STATE PROJECT NO. 857-66-0010
C.S.L.M. 0.000 – C.S.L.M. 5.844
ROUTE LA 3147
VERMILION PARISH

SUBJECT: ADDENDUM NO. 2 (CONSTRUCTION PROPOSAL REVISION)
ELECTRONIC BIDDING AMENDMENT NO. 1

STATE HIGHWAY

Typical Section for Proposed Roadway

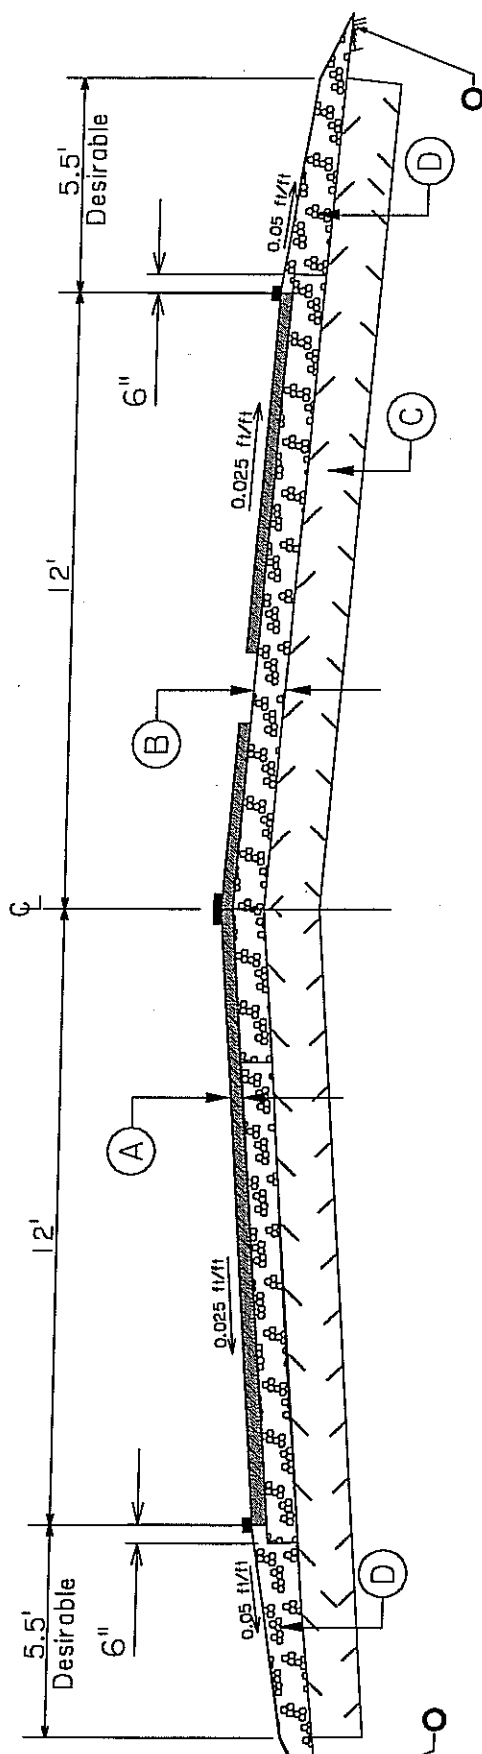
SHEET NUMBER	7	PARISH	VERMILION	PROJECT	857-66-0010	STATE	857-66-0010	BY	cdm	REVISION DESCRIPTION	3/16/09	DATE	1	NO.
											Revised tables

Asphaltic Surface Treatment									
APPROX. BEG. STATION	APPROX. ENDING STATION	DESCRIPTION	LENGTH (FEET)	WIDTH (FEET)	Aggregate (S2) (507-02-00200) (SQUARE YARDS)	Aggregate (S2) (507-02-00200) (SQUARE YARDS)	Aggregate (S3) (507-02-00300) (SQUARE YARDS)	Asphaltic Material (507-01-00100) (GALLONS)	
10+00	129+33	ROADWAY	11,933	24	31,821	31,821	31,821	31,185	
129+33	134+17	BRIDGE EXCEPTION	484	-	-	-	-	-	
134+17	140+42	ROADWAY	625	24	1,667	1,667	1,667	1,633	
140+42	140+75	BRIDGE EXCEPTION	33	-	-	-	-	-	
140+75	154+67	ROADWAY	1,392	24	3,712	3,712	3,712	3,638	
154+67	155+00	BRIDGE EXCEPTION	33	-	-	-	-	-	
155+00	170+51	ROADWAY	1,551	24	4,136	4,136	4,136	4,053	
170+51	175+23	BRIDGE EXCEPTION	472	-	-	-	-	-	
175+23	312+02	ROADWAY	13,679	24	36,477	36,477	36,477	35,748	
312+02	316+93	BRIDGE EXCEPTION	491	-	-	-	-	-	
316+93	318+58	ROADWAY	165	24	440	440	440	431	
TOTALS:					78,253	78,253	78,253	76,688

CLASS II BASE COURSE (6" THICK) (STONE ONLY)					
APPROX. BEG. STATION	APPROX. ENDING STATION	DESCRIPTION	LENGTH (FEET)	WIDTH (FEET)	CLASS II BASE COURSE (6") (302-02-02080) (SQUARE YARDS)
10+00	129+33	ROADWAY	11,933	25	33,147.2
129+33	134+17	BRIDGE EXCEPTION	484	-	-
134+17	140+42	ROADWAY	625	25	1,736.1
140+42	140+75	BRIDGE EXCEPTION	33	-	-
140+75	154+67	ROADWAY	1,392	25	3,866.7
154+67	155+00	BRIDGE EXCEPTION	33	-	-
155+00	170+51	ROADWAY	1,551	25	4,308.3
170+51	175+23	BRIDGE EXCEPTION	472	-	-
175+23	312+02	ROADWAY	13,679	25	37,997.2
312+02	316+93	BRIDGE EXCEPTION	491	-	-
316+93	318+58	ROADWAY	165	25	458.3
TOTALS:					81,513.8
